# UNITED STATES PATENT AND TRADEMARK OFFICE

10/527,408

<b>Office Action Summary</b>	<b>Application No.</b> 10/527,408	<b>Applicant(s)</b> CONRAD, WAYNE	
	<b>Examiner</b> Mr. Terry K. Cecil	<b>Art Unit</b> 1797

## **DETAILED ACTION**

**FIG. 3**

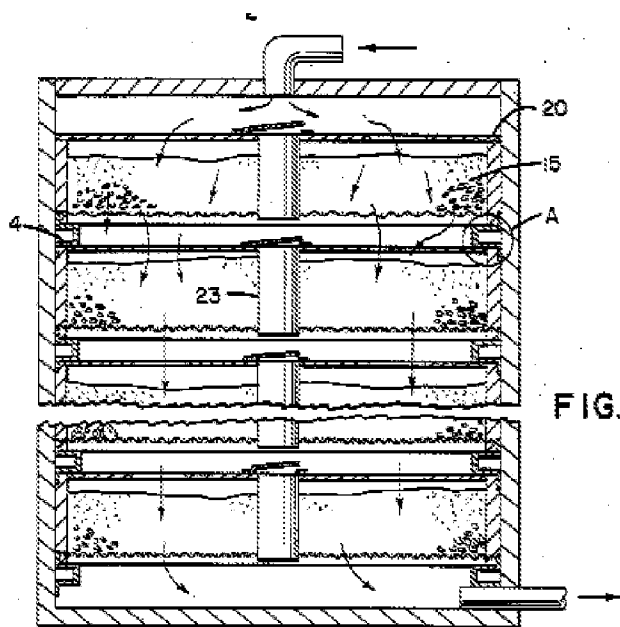
8. Claims 1-6 are rejected under 35 U.S.C. 102(b) as being anticipated by Barbaro (U.S. 4,906,381). Barbaro teaches a water treatment apparatus having an inlet port 11 and an outlet

port 12 and a plurality of removable container modules 15 including sand therein (col. 1, line 60; col. 2, lines 35-51) [as in claim 1-5]. As shown by the arrows, flow through the modules is serial.

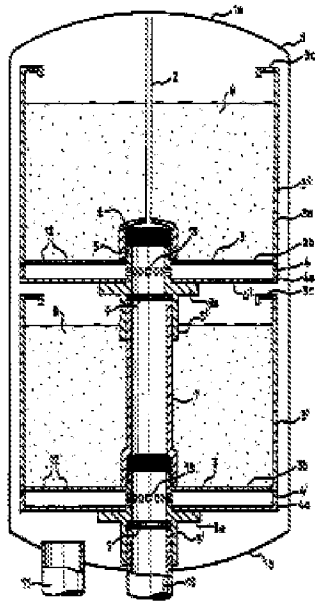
9. Claims 1-5 are rejected under 35 U.S.C. 102(b) as being anticipated by GB 2,276,330, hereinafter "330". The threaded connectors allow each of the sand containers to be removable [as in claims 1-5].

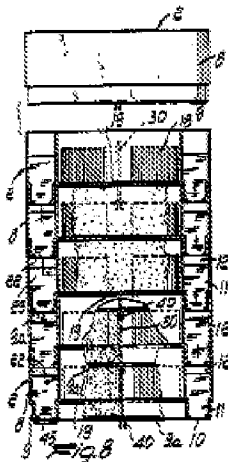
10. Claims 1-6 are rejected under 35 U.S.C. 102(b) as being clearly anticipated by EP 0381032, hereinafter '032.

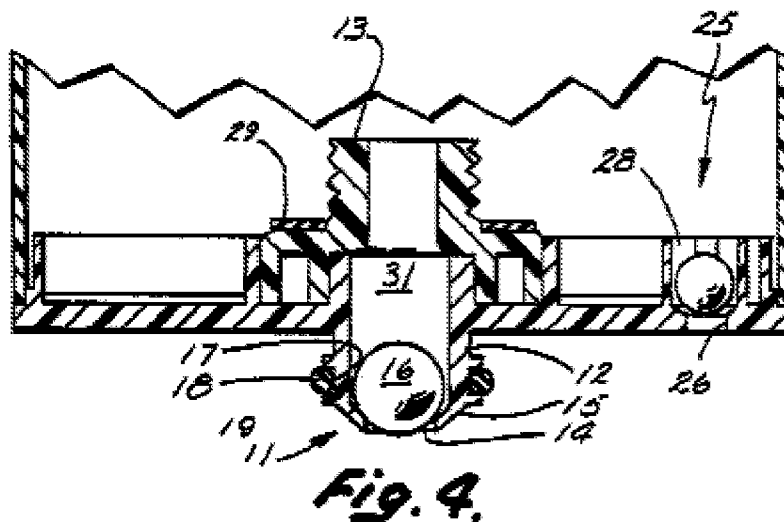
Holland in view of Gershon doesn't teach the filtering elements to be individually removable and having respective inlet and outlet ports as well as sealing elements. However such is taught by Kool. The inlet and outlet ports and sealing elements are shown below [as in claims 7-8].
